Service Bulletin

S.B. No: 75

Title: INSPECTION OF RUDDER PEDAL SLIDER/HEATER DISTRIBUTION BOX CLEARANCE

Issue 4: Note "Only applicable" added to Compliance. Works Numbers added to Applicability, extra washer added at para 3.1; at para 3.3.2 part number corrected

FIG 1

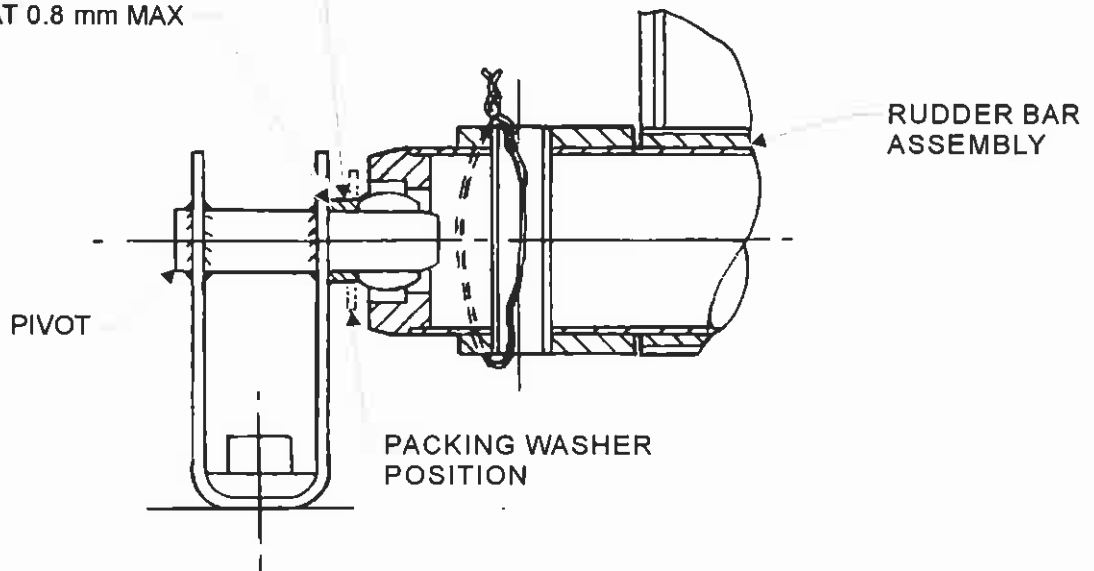
- 3.1 Check rudder bar packing is in accordance with the following, Ref. Fig. 1:

At each rudder bar pivot position (4 places) there should be one spacer T67M-45-507 **OR** one off washer 126-23-748 (AN960-516) and up to a maximum of two off 126-23-749 (AN 960-516L) ie 3 washers maximum.

If end float of greater than 0.8mm is present, then 1 off only packing washer may be added at each pivot position as required, ie 126-23-105 M8 washer or 126-23-748 or 126-23-749 washers.

If packing washers are required on the right hand rudder bar (T67M-45-259) then the packing washer (or the thicker washer if a thick and thin washer are required) should be placed at the outboard pivot.

Ensure maximum end float is not greater than 0.8mm and that brake cylinders are not subject to undue side load.

SPACER T67M-45-507
OR
1 OFF 126-23-748
PLUS
1 OR 2 OFF 126-23-749
WASHERS MUST BE FITTED

END FLOAT 0.8 mm MAX

FIG 4

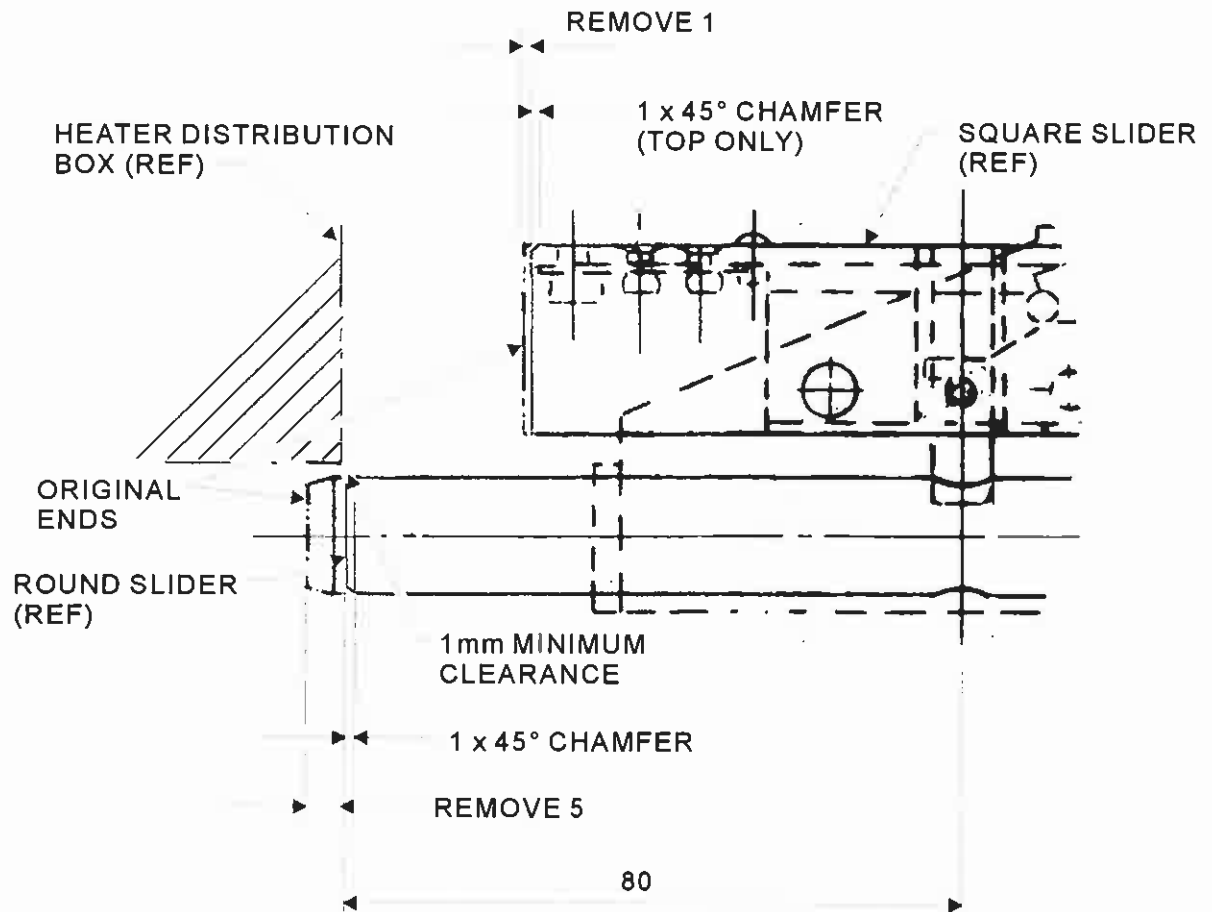
- 3.3 Modify pedal assy No.2, as follows:
 - 3.3.1 Remove No.2 pedal assy and modify as per Figure 4.

Note: Modify both square and round slider.
 - 3.3.2 No.2 pedal assy to be re-identified as T67G-03-851 and Mod M663. Annotate Mod M663 incorporated.
 - 3.3.3 If clearance, ref paragraphs 1. and 2, is achieved, annotate in Log Book "SB No.75 complied with". If not, proceed to paragraph 3.4.
- 3.4 Check heater box seating as follows, ref. Figure 5:
 - 3.4.1 Remove heater box and counter bore holes in accordance with Figure 5, Section A-A.
 - 3.4.2 Replace box and check seating. If box top flange fouls cleat cloth joining Frame 1 to Frame 2, then it is to be removed in accordance with Figure 5, Section B-B.
 - 3.4.3 Replace box. If clearance, ref paragraphs 1 and 2, is achieved, annotate in Log Book "SB No.75 complied with".
 - 3.4.4 If clearance is not achieved, then inform SAL.

DIMENSIONS IN MILLIMETRES
 ETCH PRIME CUT ENDS
